DATE: September 21, 2020
TO: Blue Bird Owners
Subject: RECALL R19AF, Safe Fleet Prolo Roof Hatch Handle

IMPORTANT SAFETY RECALL NOTICE

Subject: Safety Recall 19E-042 – Prolo Hatches

OUTER HANDLE REPLACEMENT

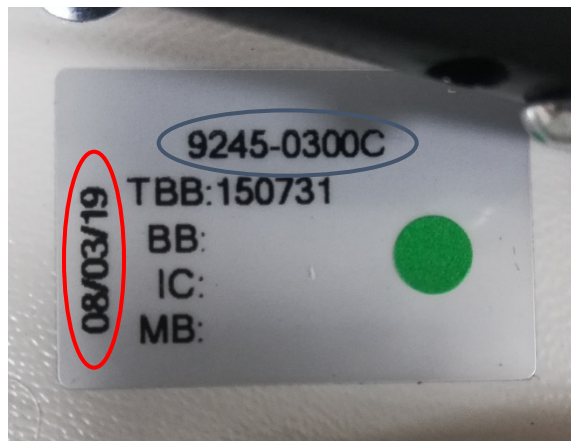
SMI has determined that some Prolo Hatches may contain defects (voids/porosity) in the outside release handle that have resulted from the casting process. Excess voids and porosity may create failure points in the handle that can lead to breakage under reasonable use. Failure of the external release handle will prevent the hatch release mechanism from being actuated from outside the vehicle. The hatch can still be opened from the outside by venting the hatch and actuating the inside release handle however this operation is not intuitive and not detailed in the required instructions located on the hatch. Failure of the external release handle does not prevent actuation of the release mechanism from inside the vehicle.

1. Check the label on the bottom of the Prolo Hatch p/n 92XX-XXXXX (circled below in blue) for dates between August 1, 2018 and May 20, 2019 (circled below in red). Units built within this date range are subject to the replacement campaign.

Replacing the outside release handle will resolve the defect. The replacement kit will include (1) replacement handle, associated hardware, and replacement instruction information.

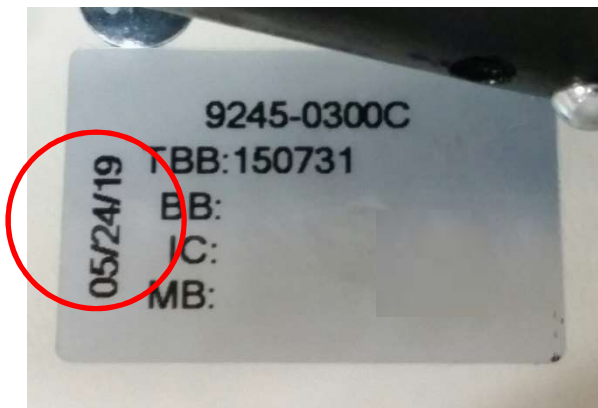
Step 2. Locate the silver "build date" sticker on the inside of the lid (located in red circle shown above)

Step 3: If the date is between 8-1-18 and 5-21-19, the hatch will need to be reworked. Dates before or after that timeframe do not need rework.
